SUBJECT: Aurora Municipal Airport
Aurora, Illinois
Kane County
Illinois Project Number: ARR-5201
SBG Project Number: 3-17-SBGP-TBD
Contract No. AU075
Item No. 06A, November 7, 2025 Letting
Addendum B

NOTICE TO PROSPECTIVE BIDDERS

Remove ALCMS modifications from the contract.

REPLACE AIRFIELD
SIGNAGE, WIND CONES,
RUNWAY 15 AND 27
RUNWAY END
IDENTIFIER LIGHTS,
AND AIRPORT
ROTATING BEACON

**ELECTRICAL VAULT
DETAILS**

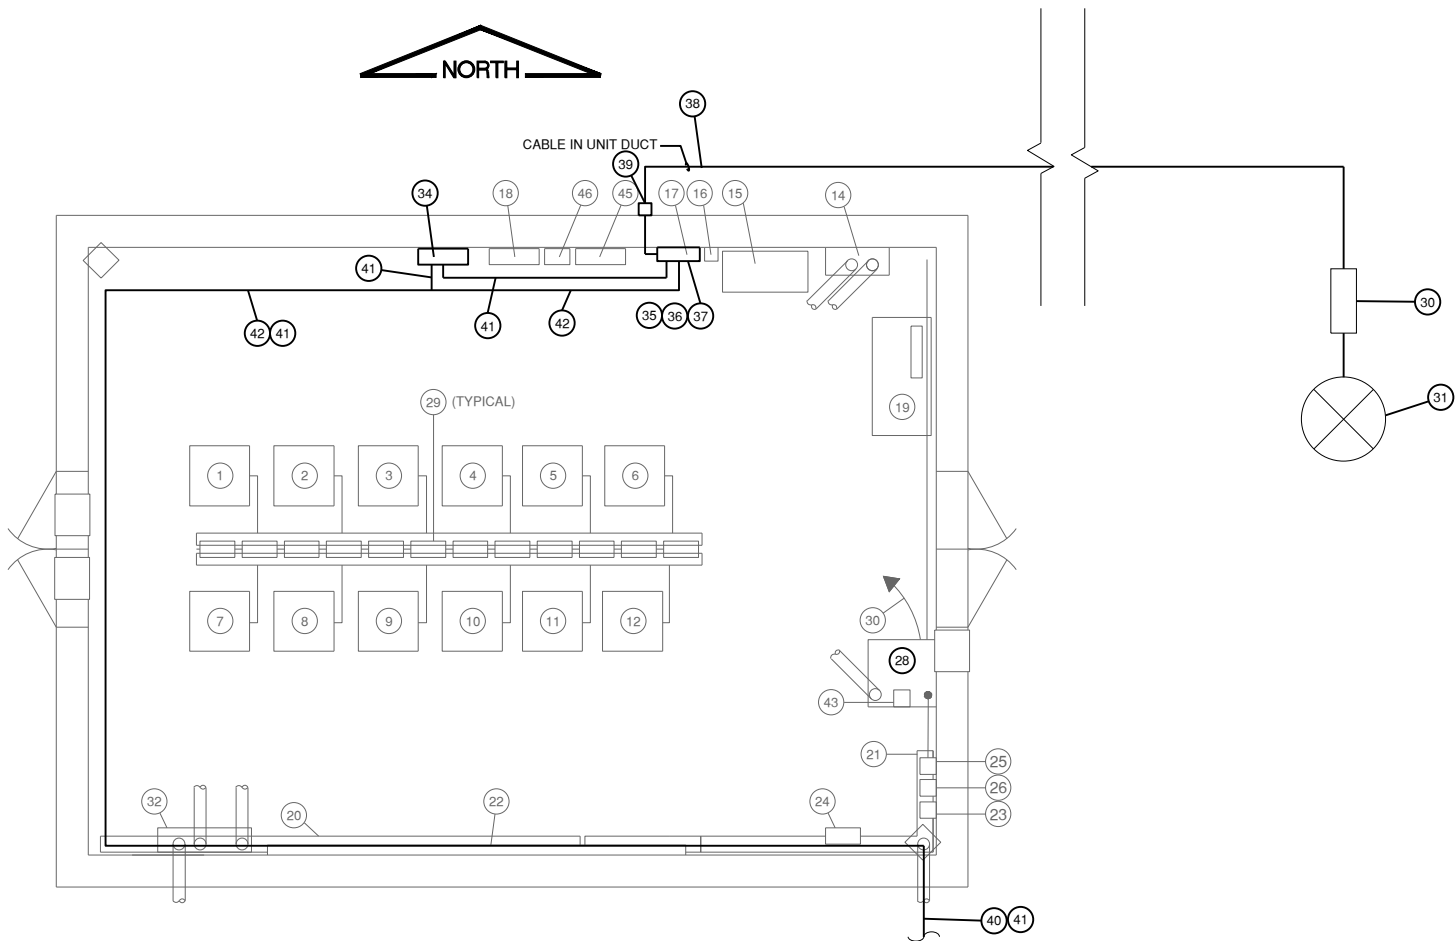
1. Sheet 25 – Electrical Vault Details
 - a. Revise Vault Nomenclature Note 28.
 - b. Add Note 4.

- EXISTING EQUIPMENT TO REMAIN IS SHOWN FOR INFORMATION ONLY. NEW WORK IS SHOWN IN BOLD.
- INSTALL LAMACOID NAMEPLATES ON ALL EQUIPMENT.
- CONTRACTOR SHALL DRILL THROUGH EXISTING VAULT BUILDING FOR NEW CIRCUIT AND SEAL CONDUIT AROUND NEW ENTRANCE AT NO ADDITIONAL COST.
- CONNECT THE NEW BEACON CIRCUIT AND NEW WINDCONE CIRCUIT TO EXISTING ALCMS CONTROLS.

- EXISTING L-890 AIRFIELD LIGHTING CONTROL AND MONITORING SYSTEM (ALCMS)EQUIPMENT RACK WITH TOUCHSCREEN MONITOR AND PRINTER
~~SHALL BE UPDATED TO INCLUDE NEW PRIMARY WINDCONE, NEW BEACON, AND NEW RUNWAY GUARD LIGHTS.~~
